SERVICE
BULLETIN
128
INFORMATIONAL

ISSUED: December 2001
MODEL AFFECTED: OHSK70
SPECIFICATION NUMBER: 72523D
DOM's AFFECTED: 1221 THROUGH 1309

Simplicity Model: 755 Snowthrower
Simplicity Manufacturer Number: 1693983

PHOTO 1

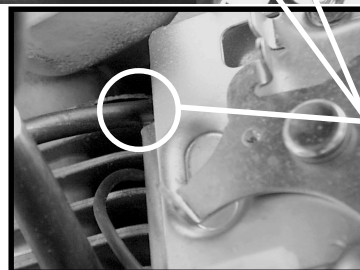
Photograph 1 shows the **INCORRECT** routing with the primer line pinched between the housing and muffler. If the engine is started with the line located in this position, the line will melt immediately on start-up causing the primer to no longer function, which results in hard starting.

Prior to sale of any 2002 Simplicity model **1693983 755 snowthrower**, please inspect them for improper routing of the line as shown in photo 1. If the line is not properly located as shown in photo 2, use a blunt object or your hand to move the line to the correct location as shown. Also check that the line routing is behind and under the fuel line as shown.
